TOWN OF FAIRLEE
ROUTE NO. I-91 LOG STA.
I-91 OVER SA-1
GENERAL PLAN & ELEVATION

WARD WELLER CO., INC.		215 OAK STREET		NATICK, MASSACHUSETTS	
VERMONT DEPT. OF HIGHWAYS					
PROJECT #1-91-2(9)					
TOWNS THETFORD AND FAIRLEE					
I-91 OVER FAIRLEE SA-1					
N.B. & S.B. BRIDGES					
ALUMINUM BRIDGE RAILING					
CUSTOMER: W.W. WYMAN					
1	1-28-70	FOR APPROVAL	BY <u>HR</u>	SCALE	<u>BR-535</u>
ISSUE	DATE	DESCRIPTION	BY	SCALE	W.W. 1002

WARD WELER CO., INC.
 213 OAK STREET
 EAST NATICK, MASS. 01742
 VERMONT DEPT. OF HIGHWAYS
 PROJECT # I-91-2(9)
 TOWNS OF THETFORD AND FAIRLEE
 I-91 OVER FAIRLEE SA-1

HANDRAIL CLAMP BAR

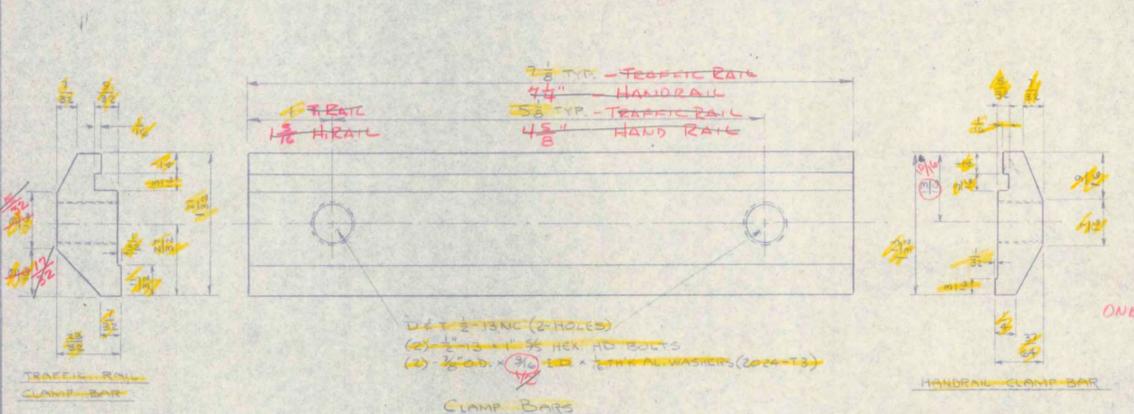
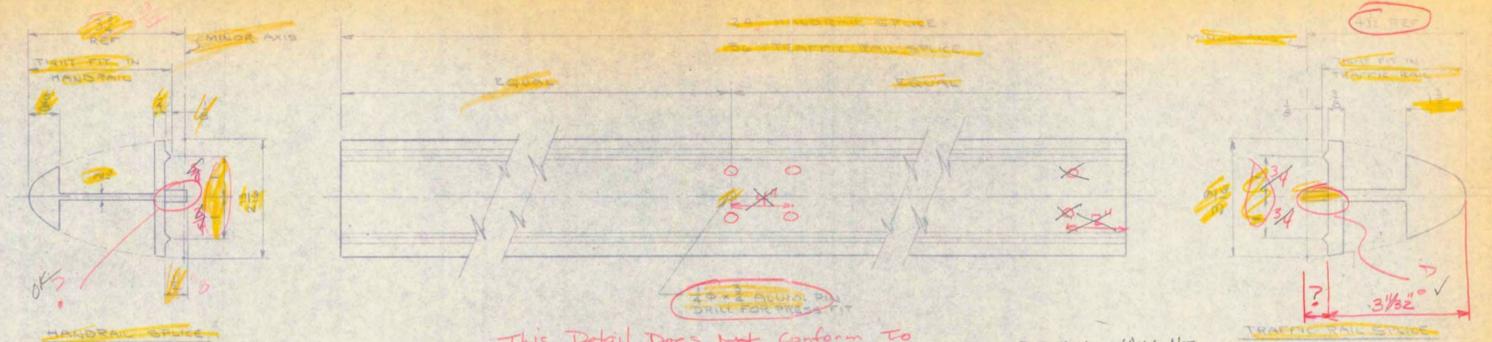
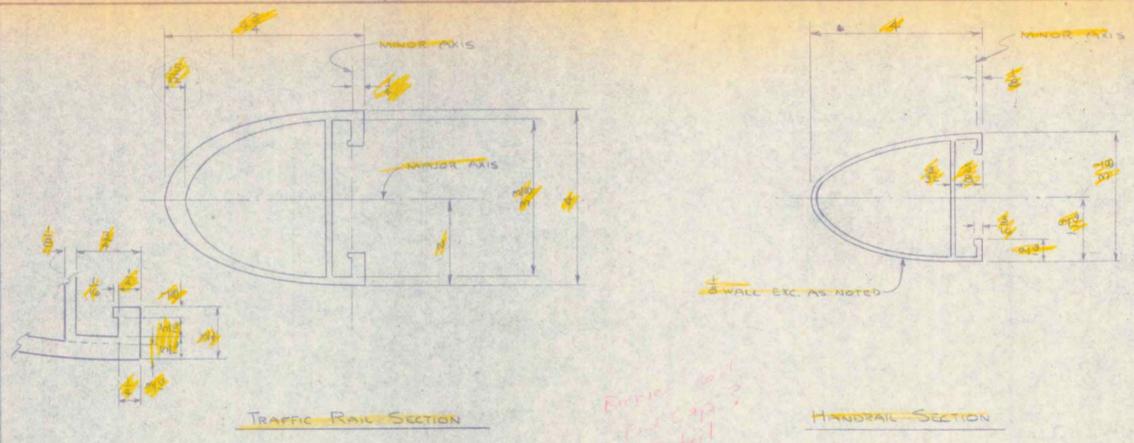
DETAIL FOR HANDRAIL CLAMP BAR DIFFERENT THAN ONE IN THE TRAFFIC CLAMP BAR.

OK - To Contractor's advantage to use one clamp bar.

RAIL CAPS
 AL. ALLOY 356-T6

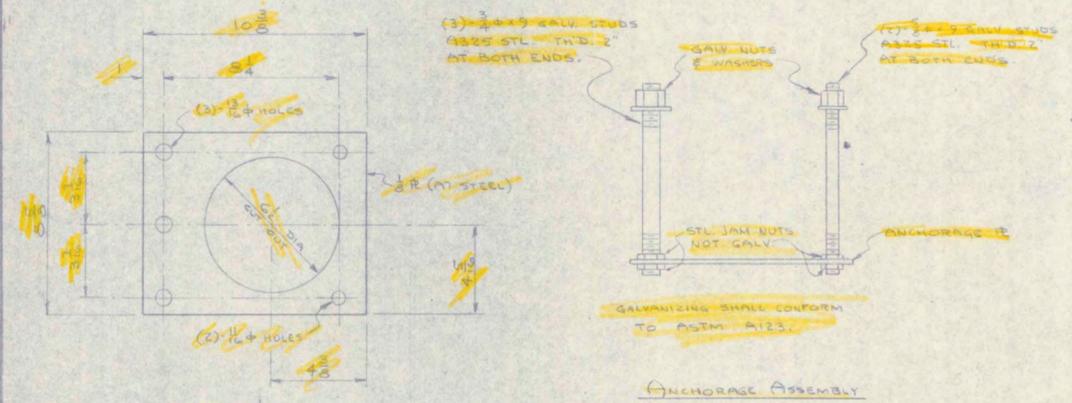
OK SINCE END CAPS WILL NOT BE USED ON EITHER PROJECT.

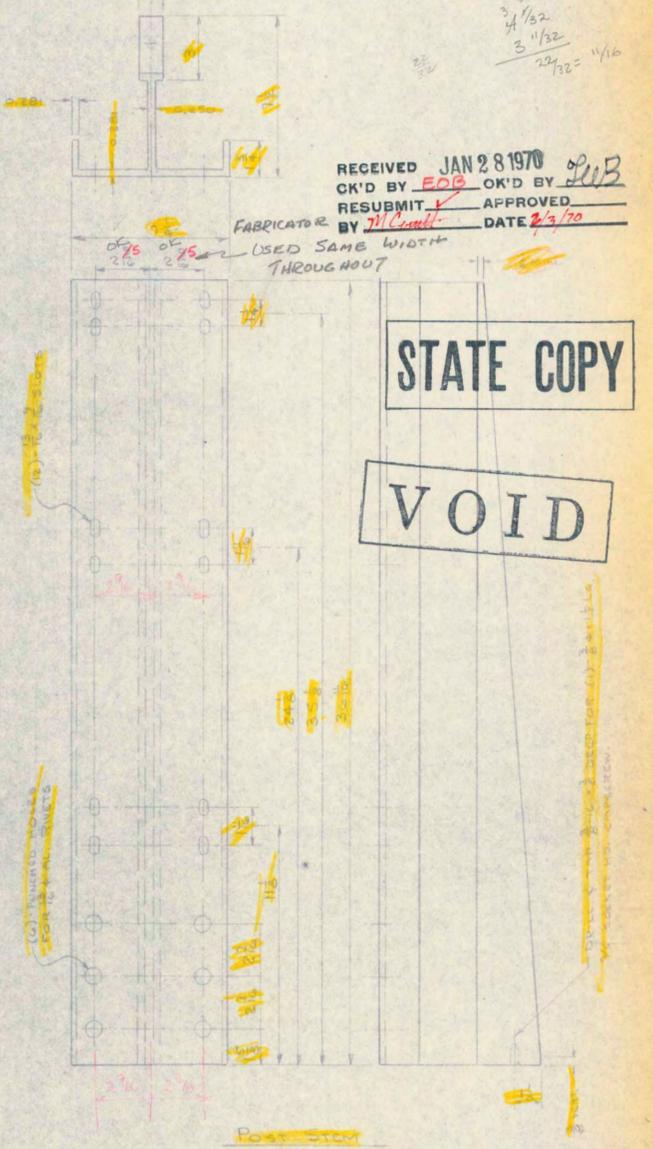
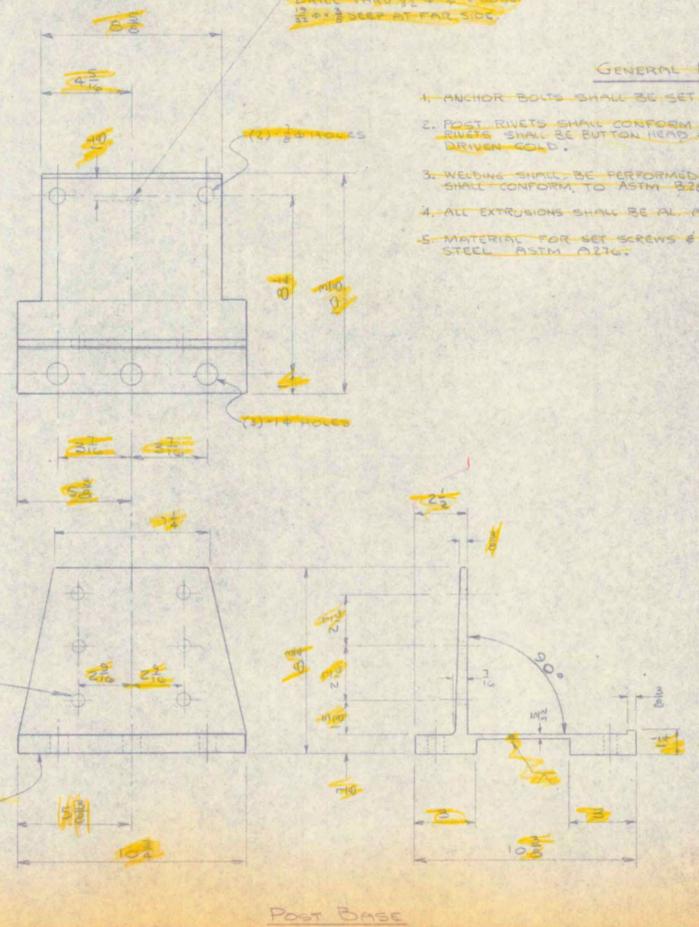
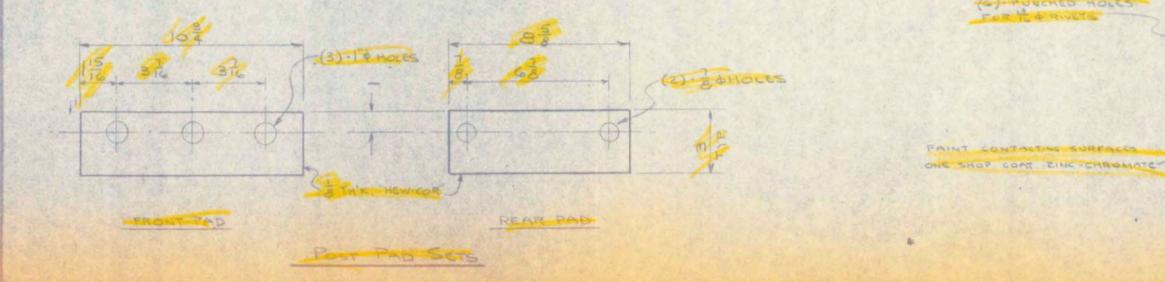
Apparently does not conform to note 6, SB-21-64.
